CITY PLAN COMMISSION

Date and Time:	July 5, 2022 6:00 PM	Location:	Community Room 933 Michigan Avenue, Stevens Point, WI
			<u>OR</u>
			<u>Zoom Teleconferencing</u>
			Meeting ID: 871 5679 2974 Passcode: 685149
			<u>By Computer:</u>
			https://us02web.zoom.us/j/87156792974?pwd=clhRTlVNYlVCdjM5SUxBWmtDMG
			<u>By Phone:</u> +1-312-626-6799 (US Chicago)

1400 River View Avenue

July 5, 2022

SHEET
L1.0

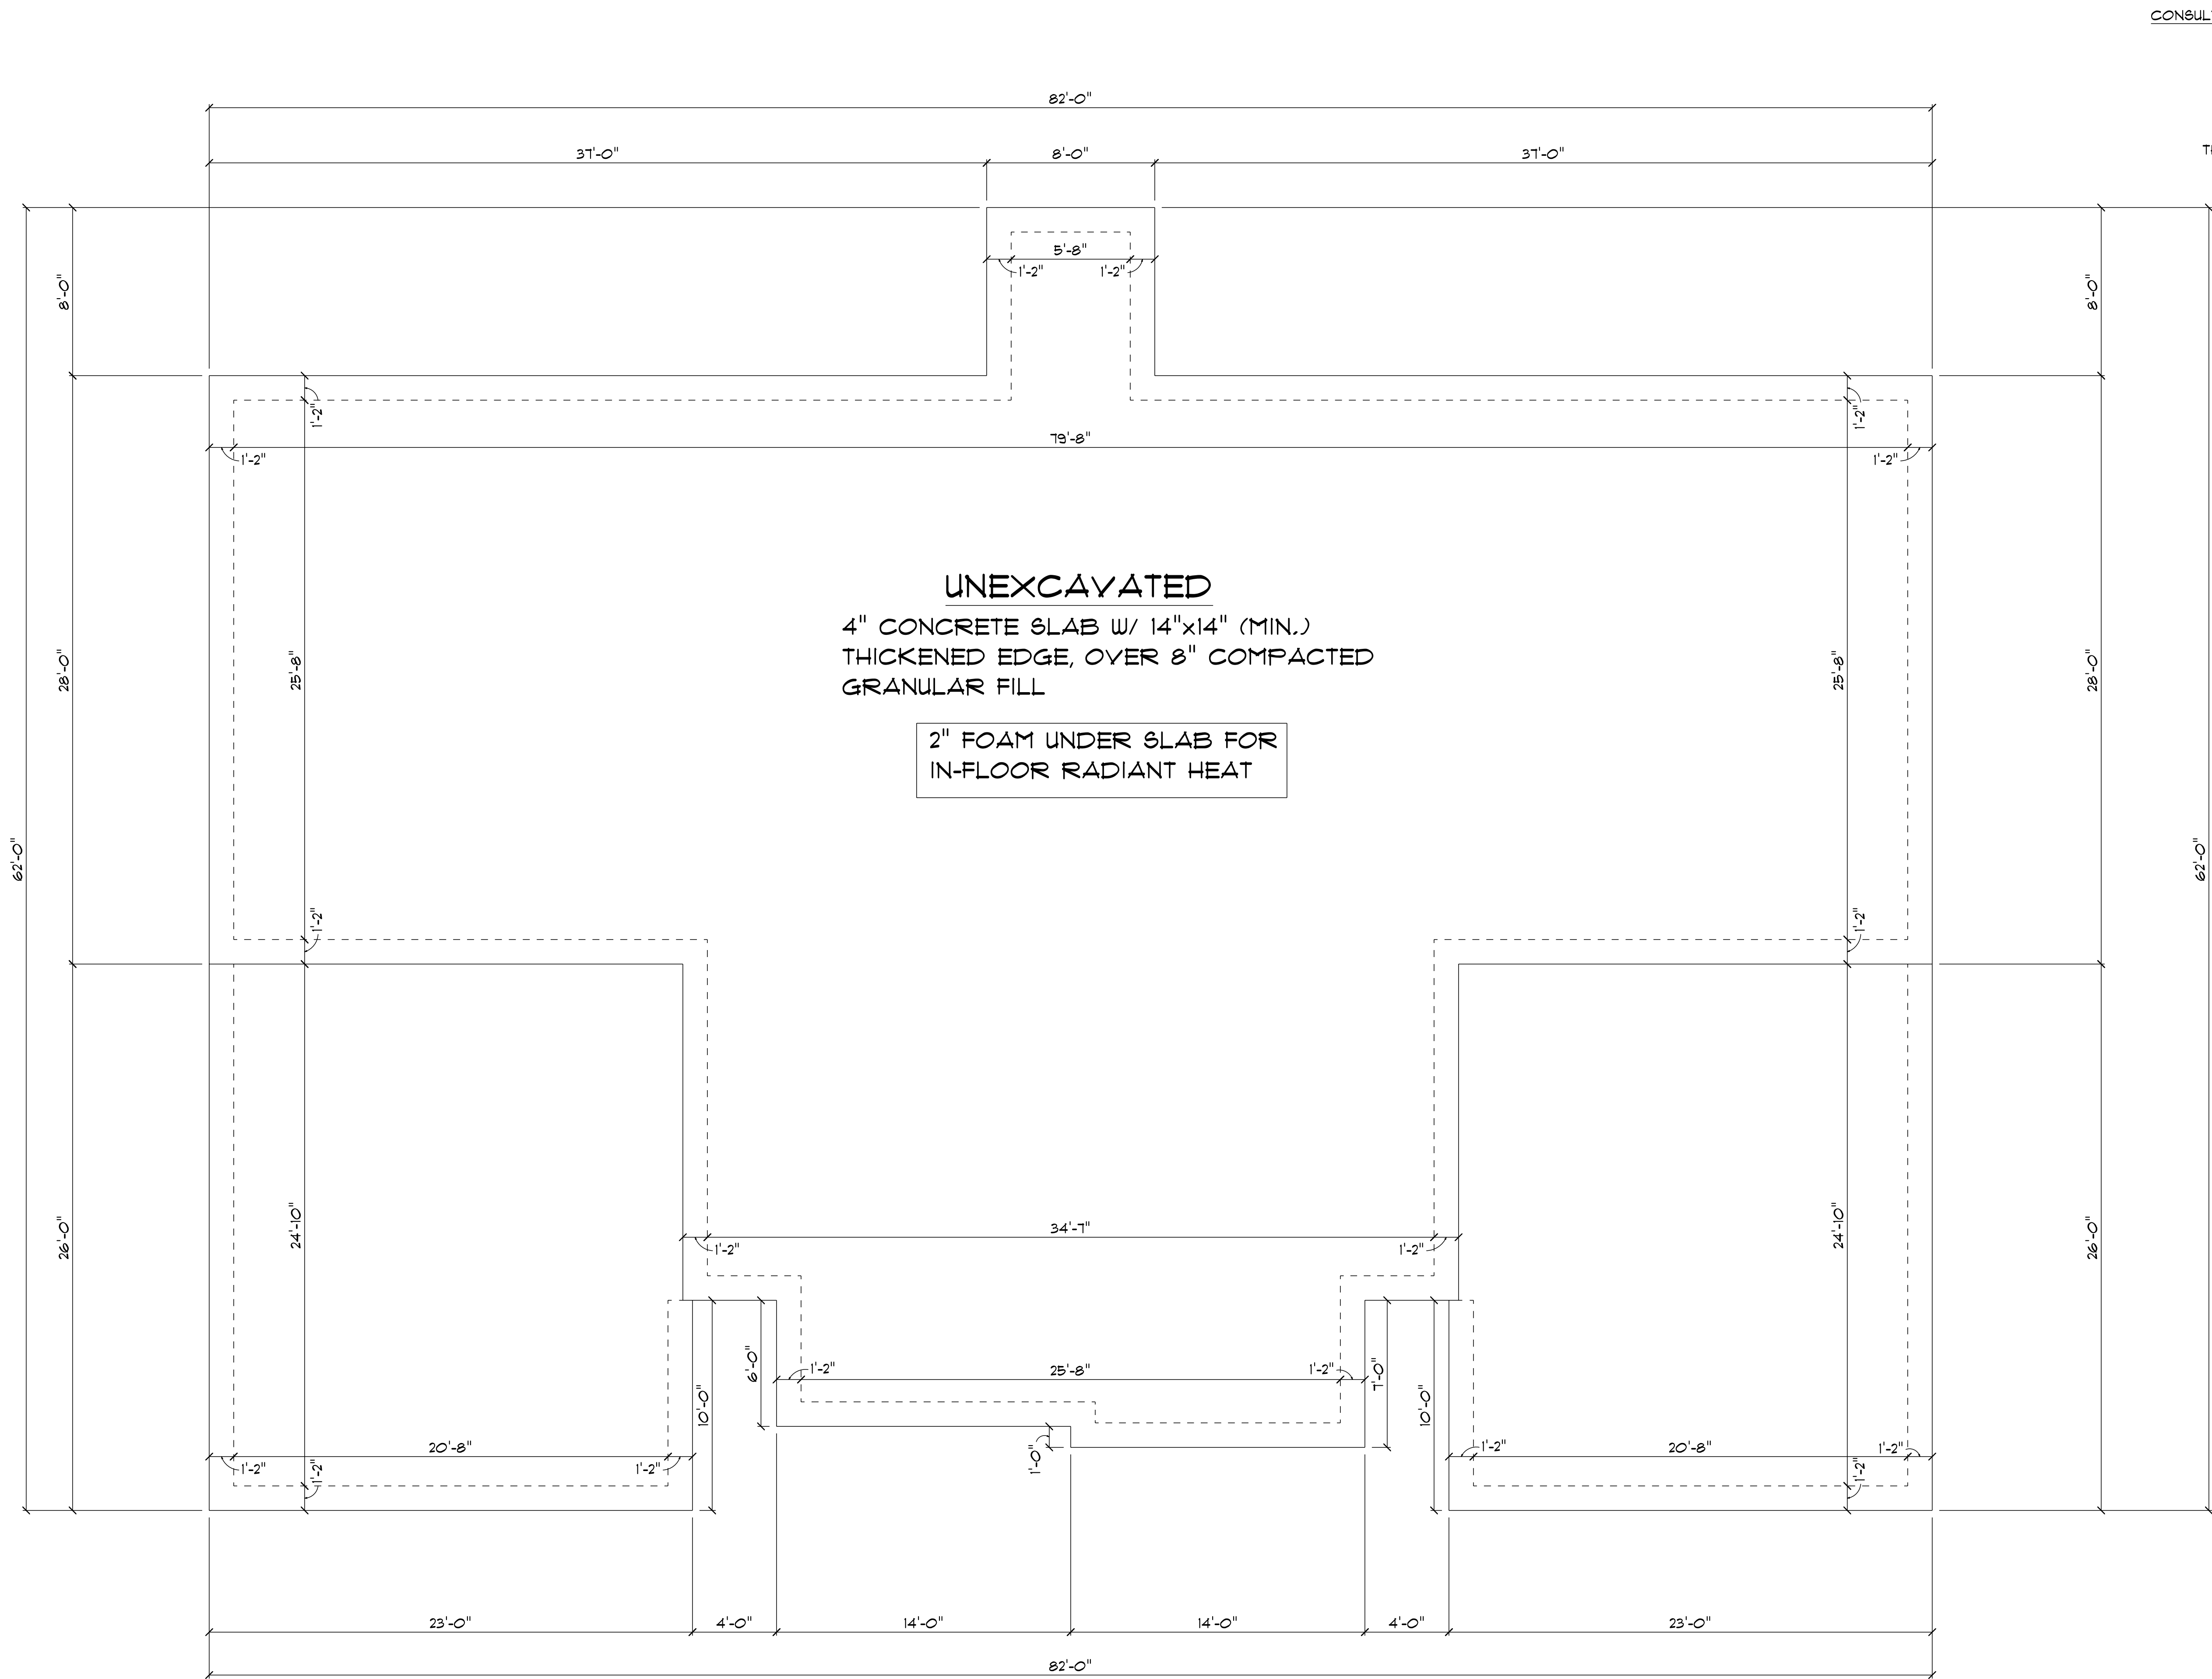
Existing mature trees along the north and west lot lines will be undisturbed and will assist in screening from adjacent single- and multi-family uses. A landscaping plan has been submitted. As a condition of approval, staff would recommend that the development team swap out the proposed red maple trees along River View Avenue with another type of species that provided greater screening from the adjacent street.

4. All walls facing a public right-of-way shall have the same architectural appeal as the front elevation proposed on each duplex.
5. The proposed red maple trees along County Highway HH shall be replaced with another type of landscape species to provide greater screening. Such landscaping specifications shall be approved by the Zoning Administrator.
6. The eastern access point off of County Road HH shall be paved using a hard surfacing material and be accompanied with a locked gate. The gate shall be at least 14 feet in width.
7. A right-of-permit shall be obtained from the Portage County Highway Department.
8. Staff shall have the ability to approve minor amendments to the site plan.

PAGE#
A3

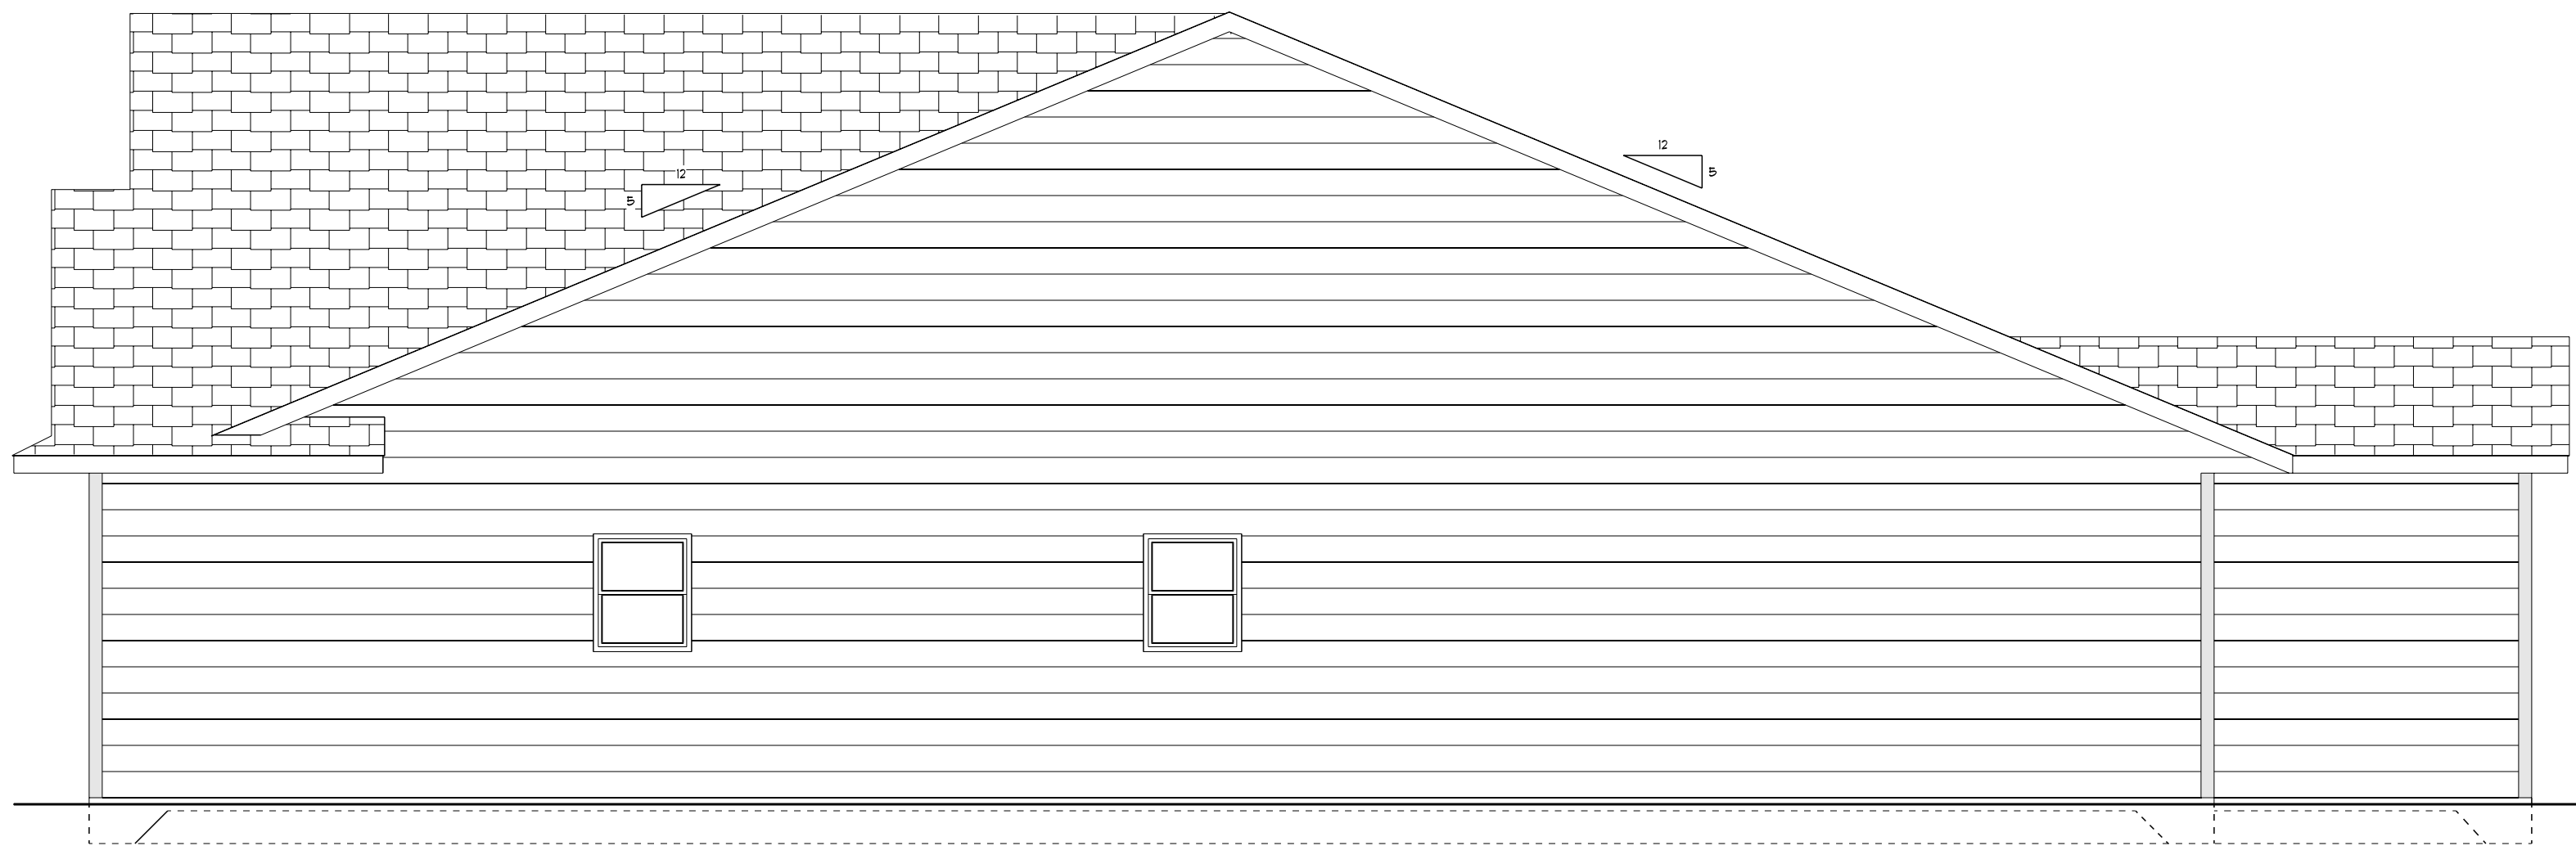
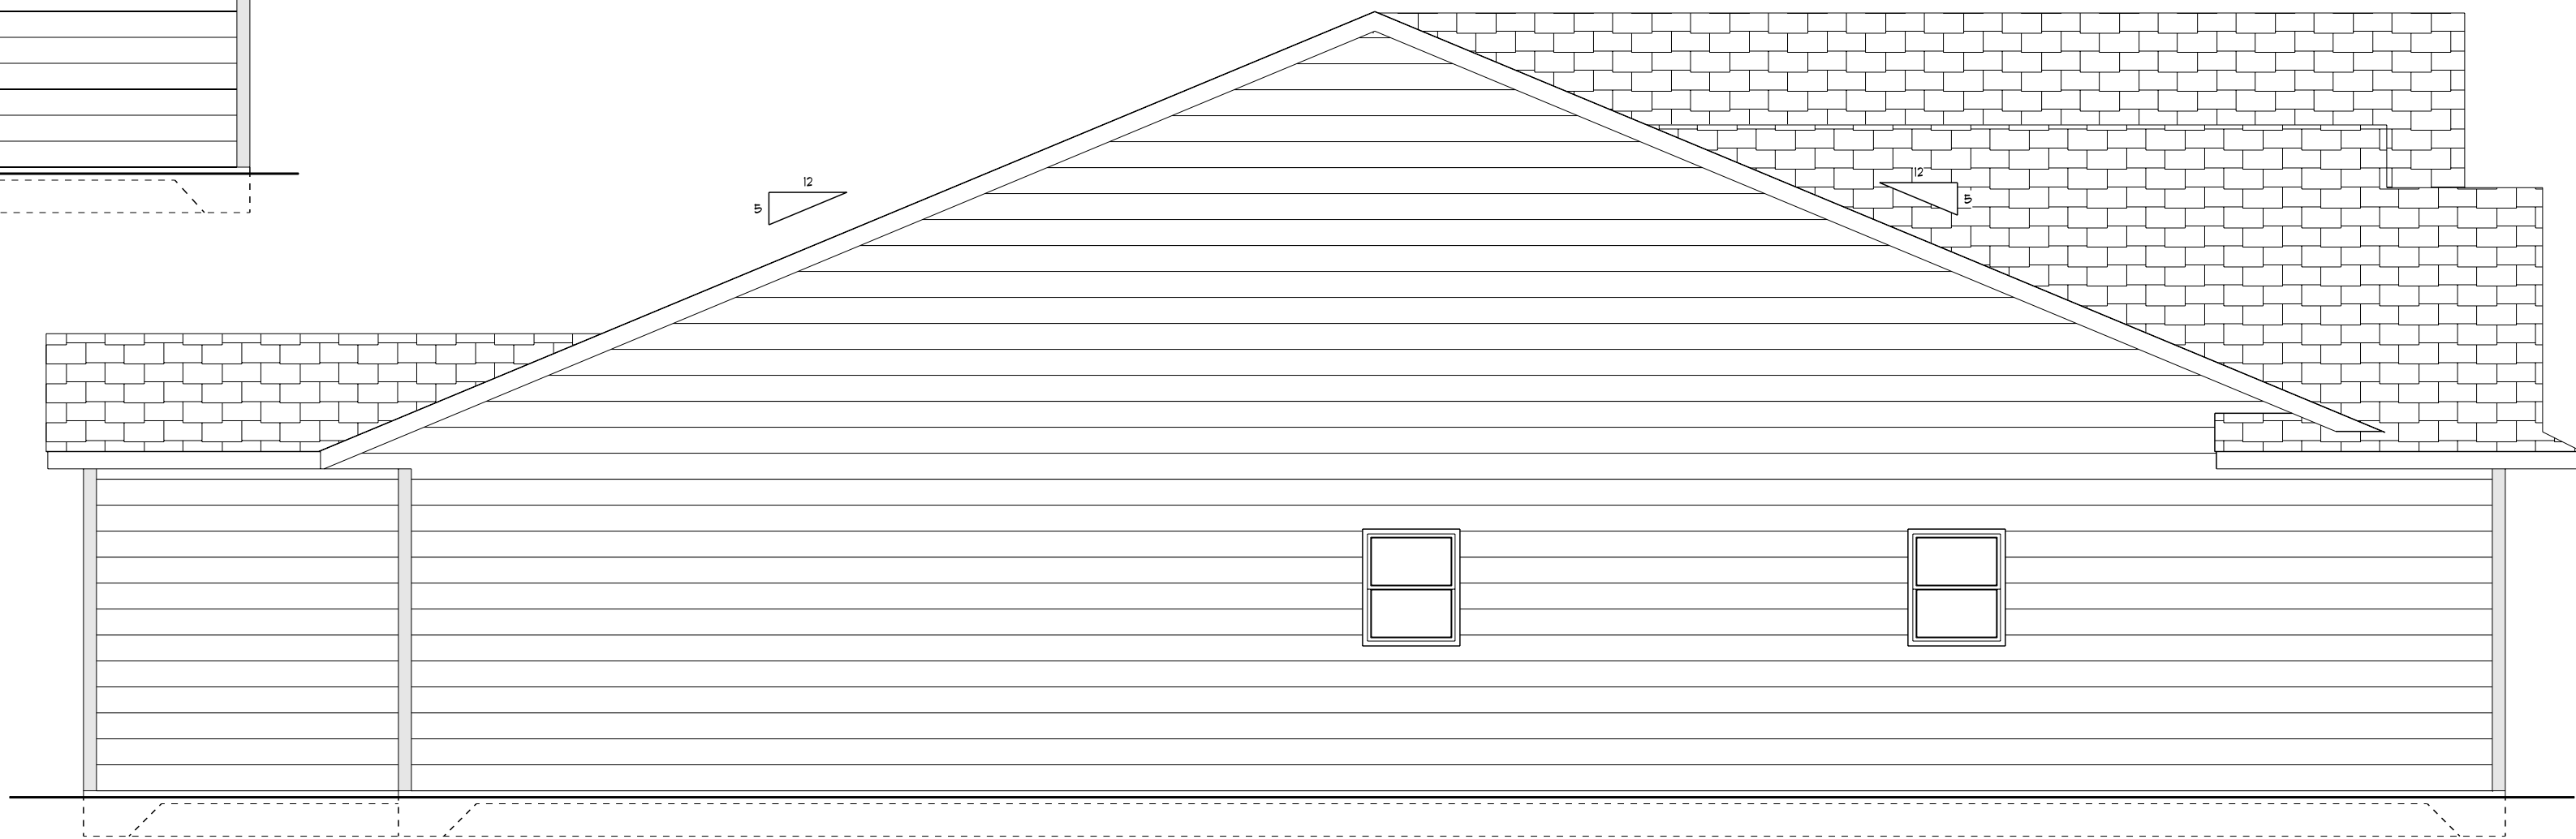
Analysis: The proposed duplexes are of a design compatible with other higher-density residential development in the city. A decorative stone façade is planned along the front door to provide aesthetic variation with siding enclosing the overhead doors.
